Pre-Inspection Mezzanine Walkthrough Checklist

NEW ELECTRONIC PAY PROGRAM (NEPP) IN METRORAIL STATIONS
L'ENFANT PLAZA - NORTH
PANEL SCHEDULE

Pre-Inspection Field Verification 9/30/2014

NEW ELECTRONIC PAY PROGRAM (NEPP) IN METRORAIL STATIONS
WATER FRONT
PANEL SCHEDULE

L’Enfant Plaza North Photo #15 – Panel NE Panel Schedule

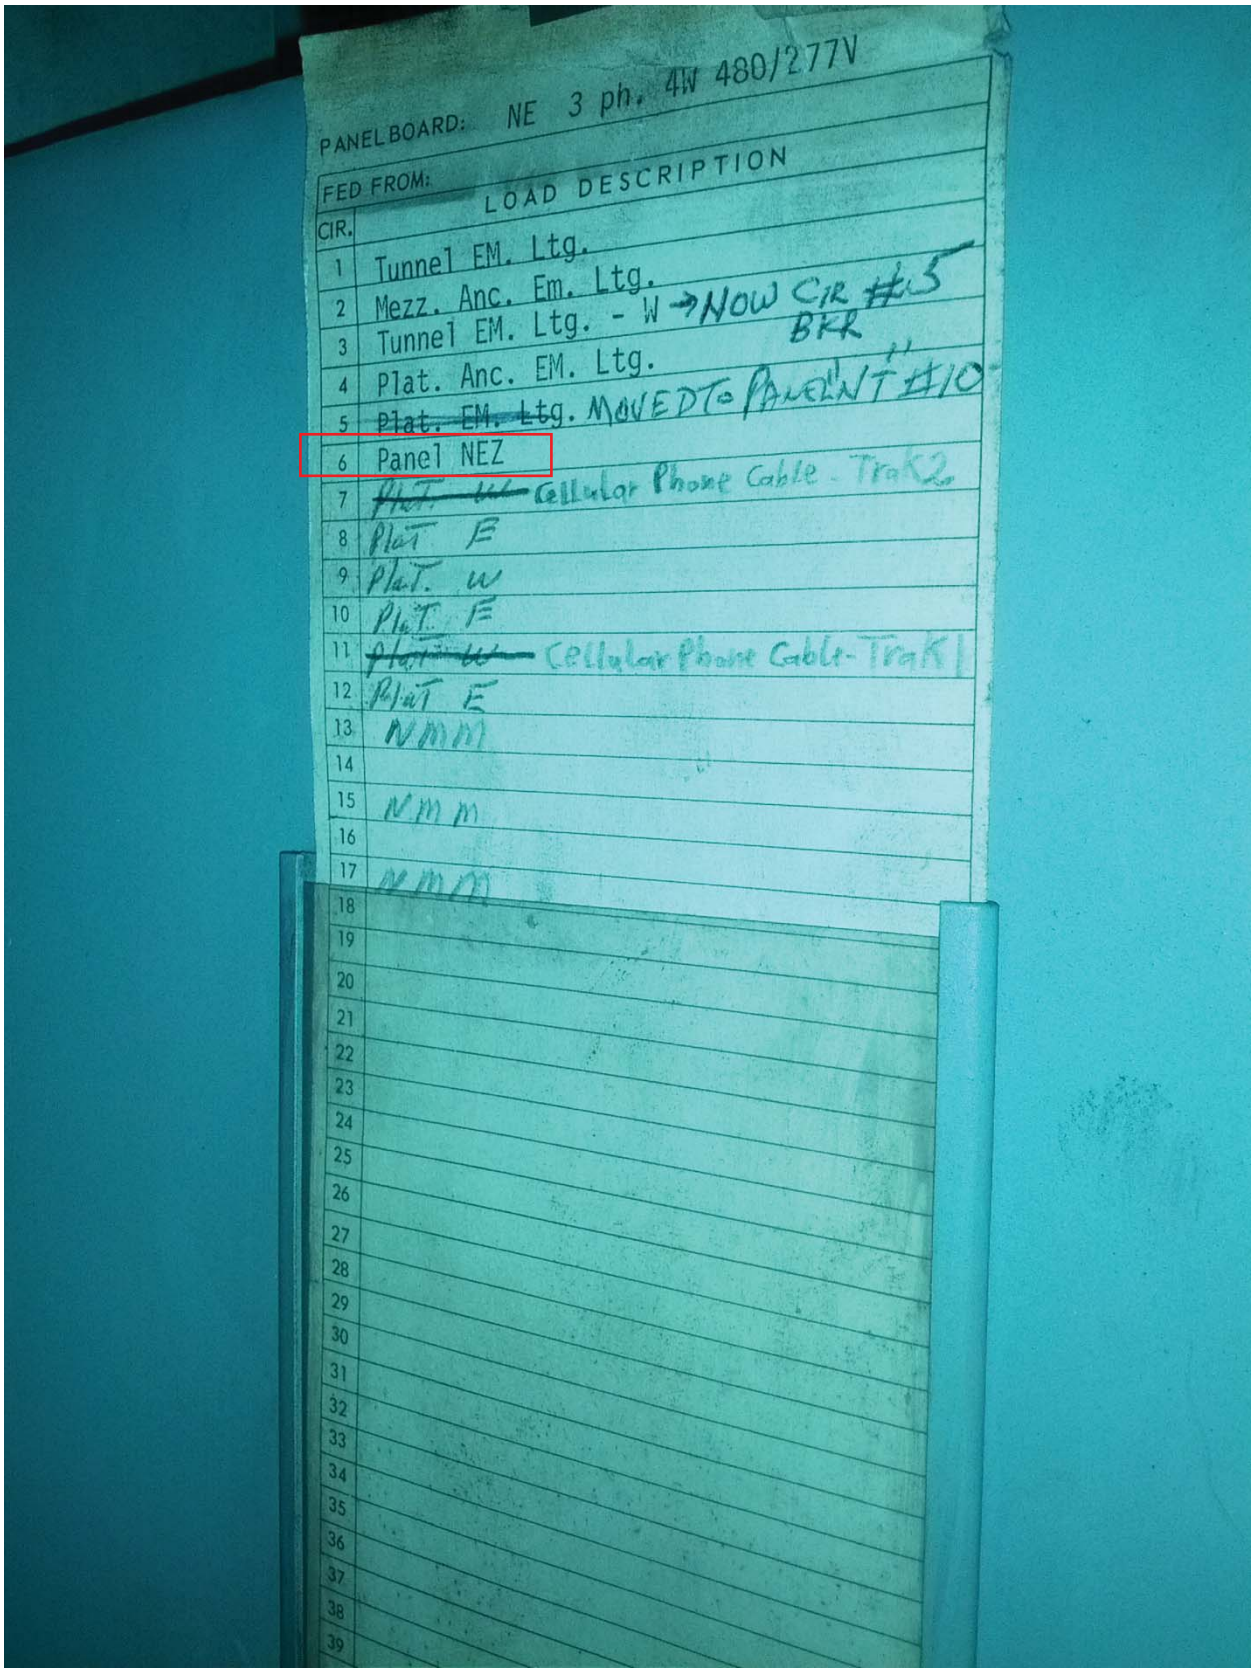
CIR.	LOAD DESCRIPTION
1	Tunnel EM. Ltg.
2	Mezz. Anc. Em. Ltg.
3	Tunnel EM. Ltg. - W → NOW CIR #15 BKR
4	Plat. Anc. EM. Ltg.
5	~~Plat. EM. Ltg.~~ MOVED TO PANEL NT #10
6	Panel NEZ
7	~~Plat. W~~ Cellular Phone Cable - Trak 2
8	Plat E
9	Plat. W
10	Plat. E
11	~~Plat W~~ Cellular Phone Cable - Trak 1
12	Plat E
13	NMM
14	
15	NMM
16	
17	NMM
18	
19	
20	
21	
22	
23	
24	
25	
26	
27	
28	
29	
30	
31	
32	
33	
34	
35	
36	
37	
38	
39

DRAWING NO.: F03-E-102

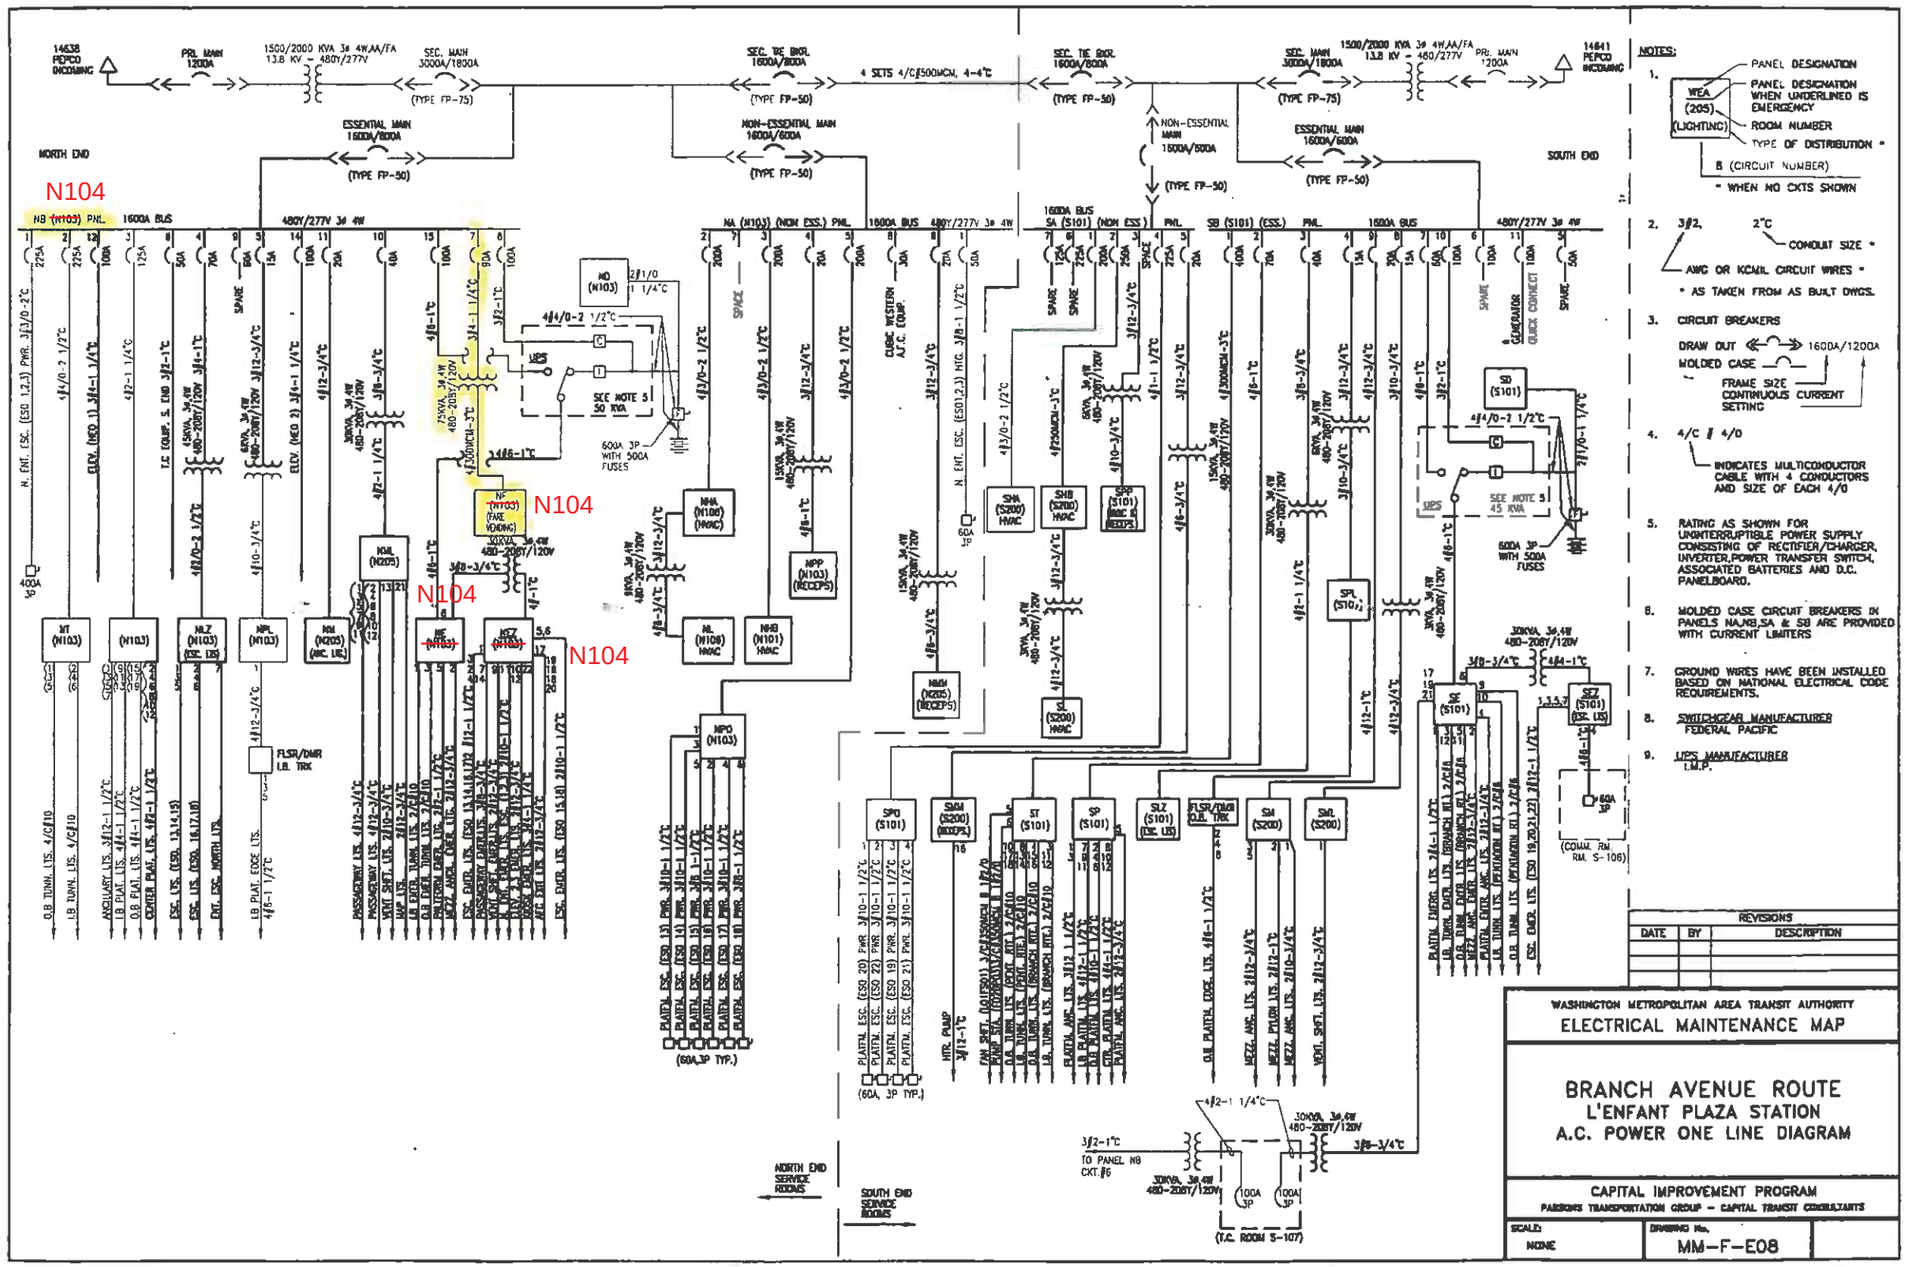
1&2 1

~~1~~

~~1&2~~

Use Circuits #27 and #29

DRAWING NO. F04-E-102

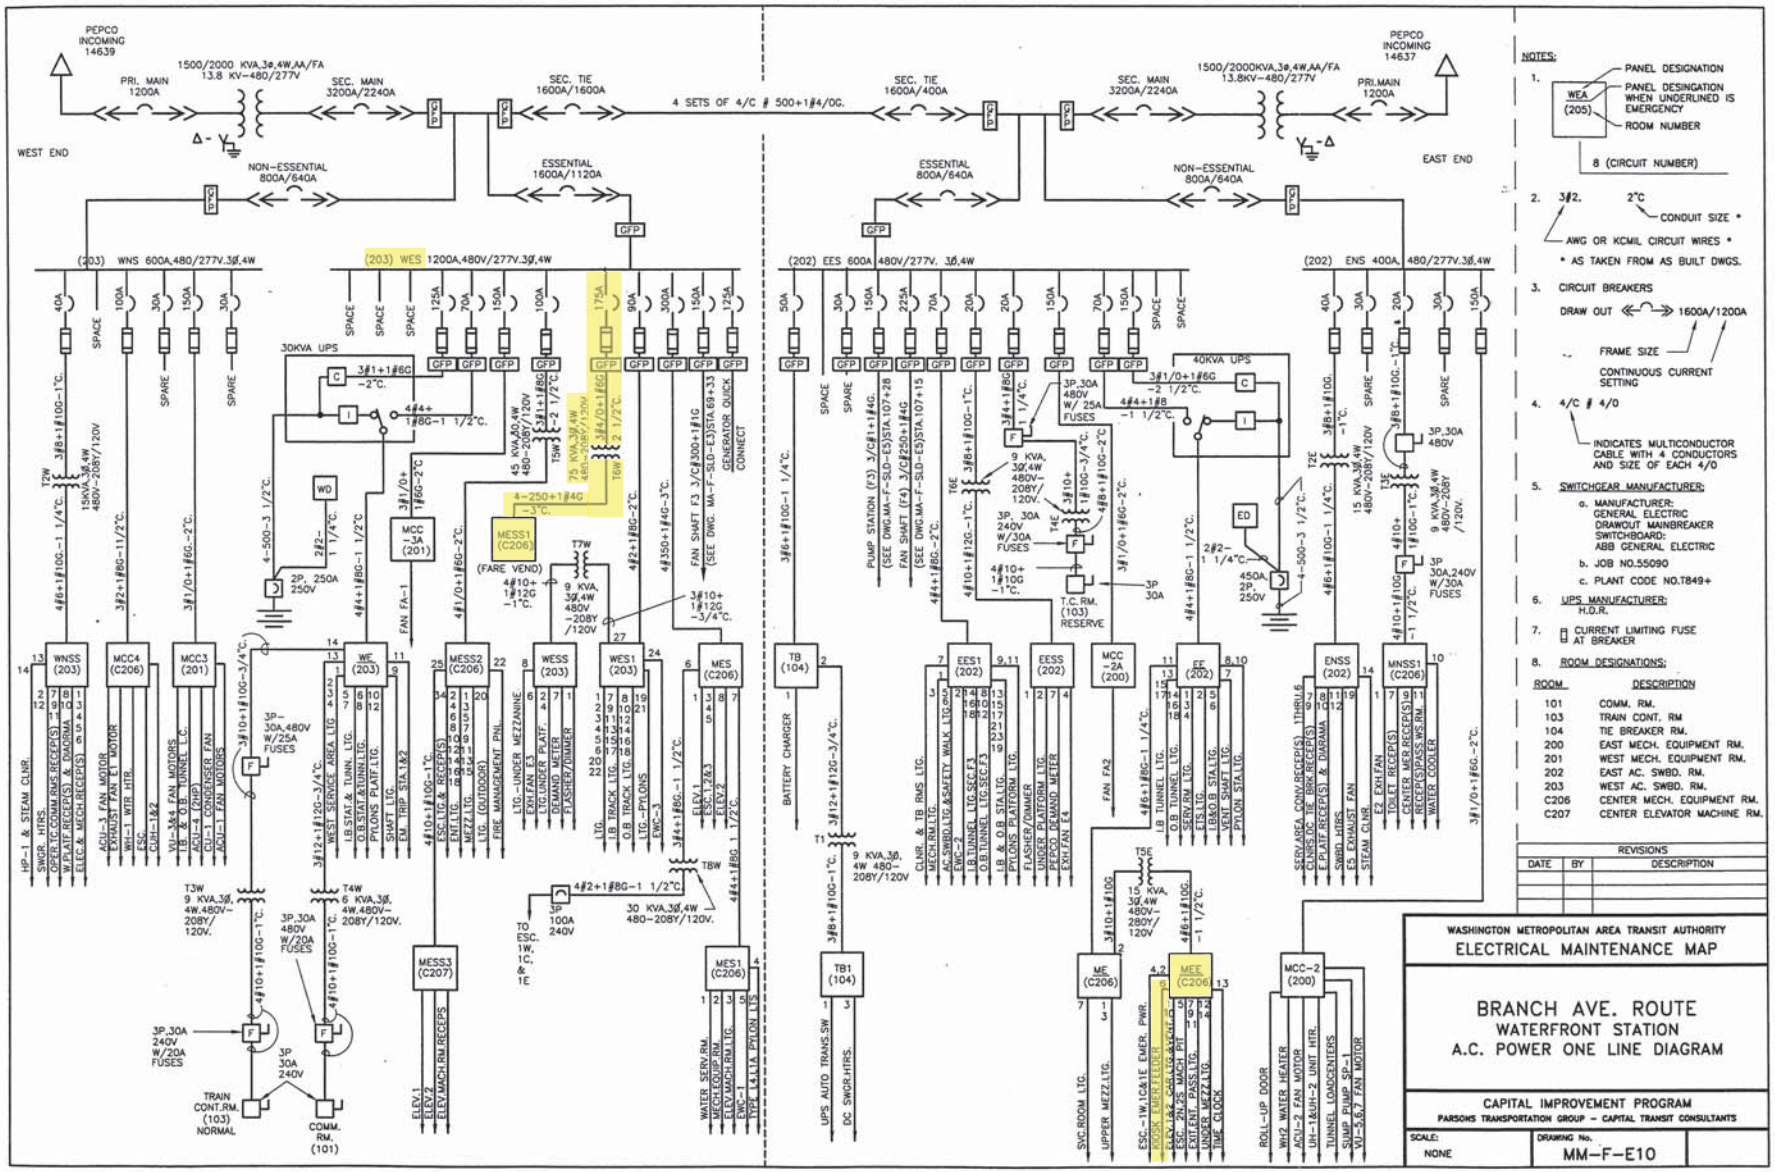
AFC Panel MESS-1 (Rm C206) feed from WAC Essential (Rm 203)

XFMR Breaker "Panel MESS-1" - (Breaker 6)

NOTES: A. EXISTING PANEL "MESS-1" IS FED FROM 277/480V, 3ø, 4W EXISTING SWITCHBOARD "WES" LOCATED IN ~~AC SWBD. RM. 203, CIRCUIT #6 175A/3P~~ VIA 75KVA TRANSFORMER (SEE ATTACHED DWG. MM-F-E10).

W. NAVY YARD STATION
MEZZANINE LAYOUT

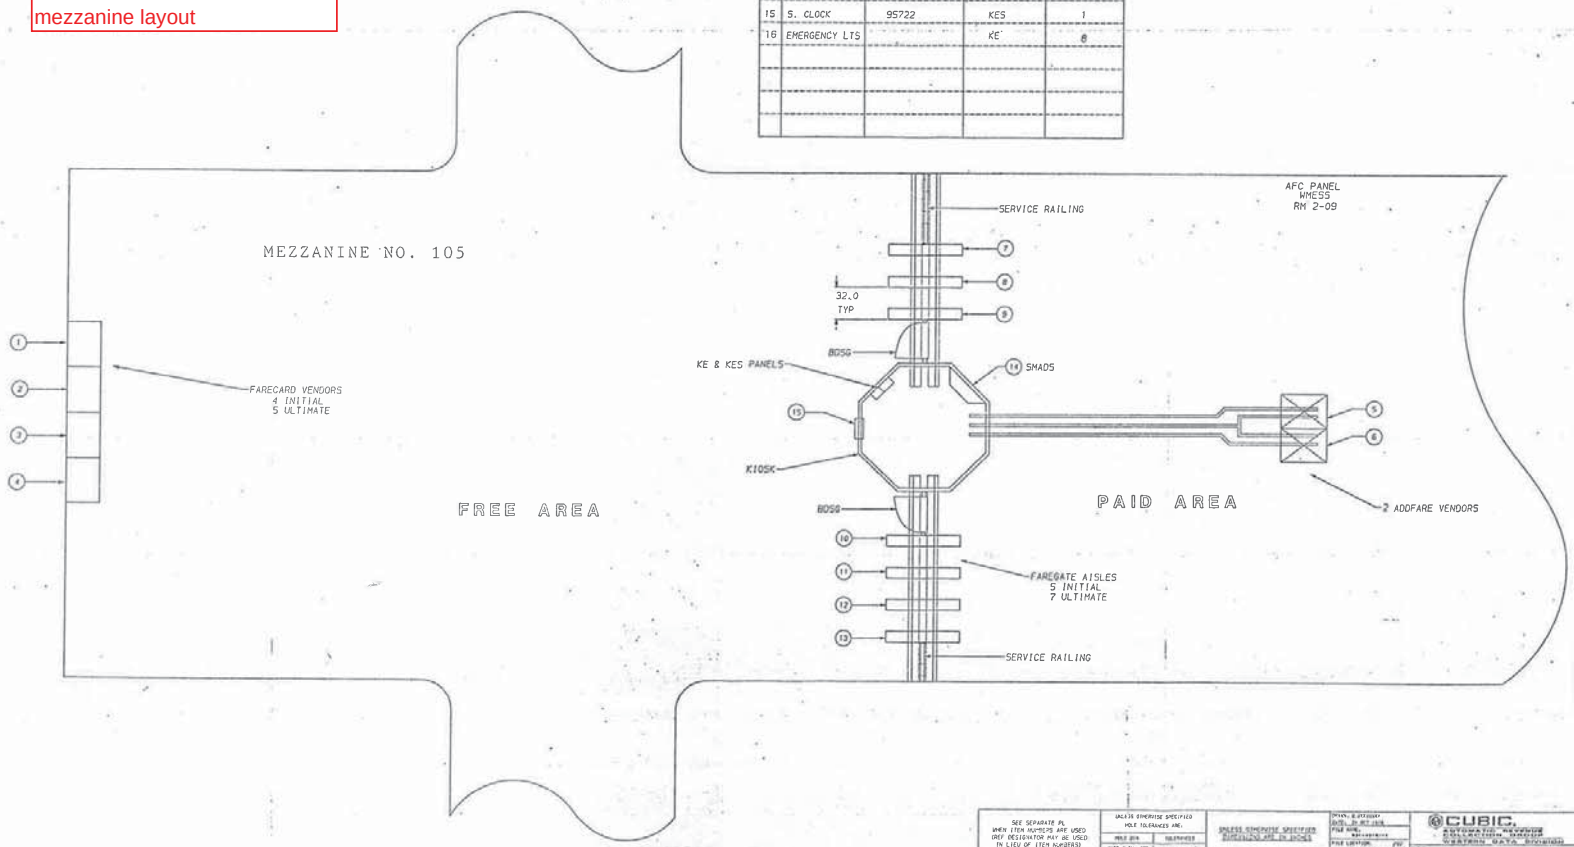
Mezzanine layout is obsolete; need new street-level mezzanine layout

DRAWING NO: F05-E-102

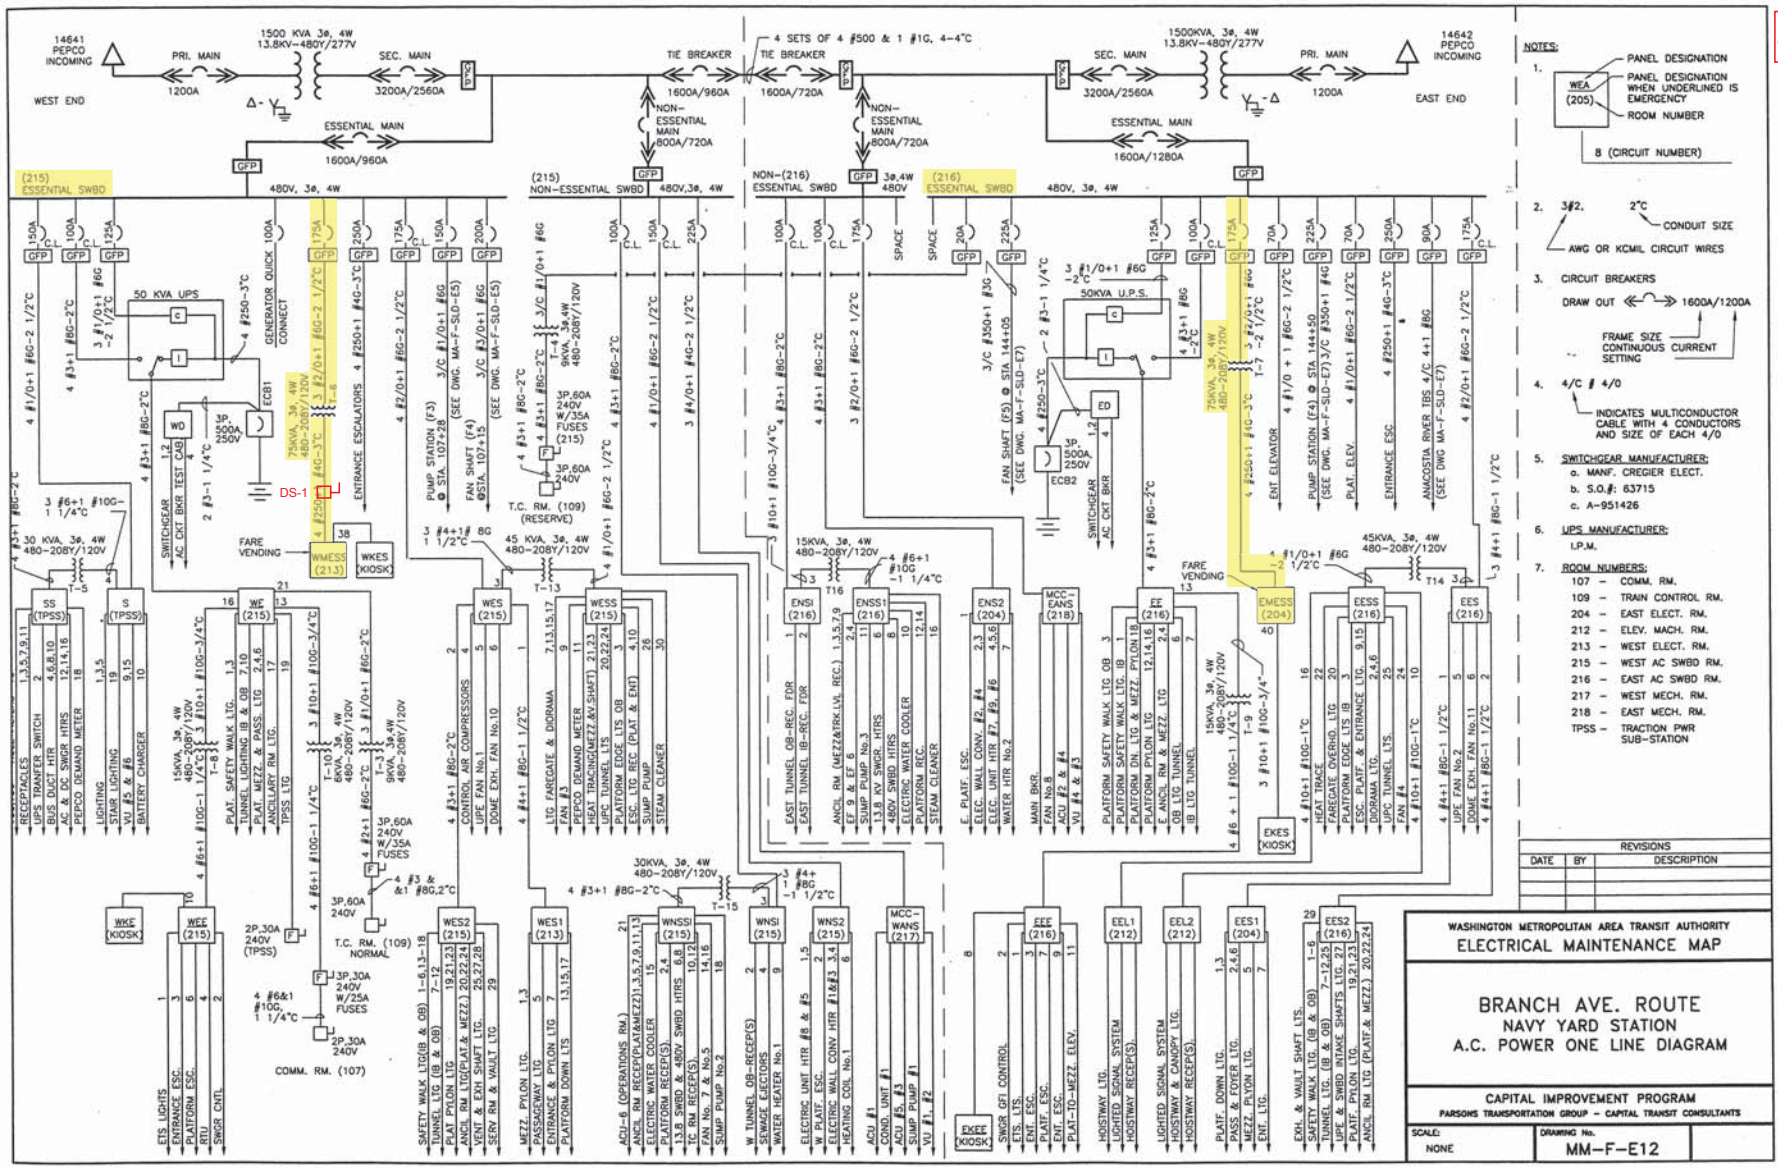
ATM is #31 in WMESS
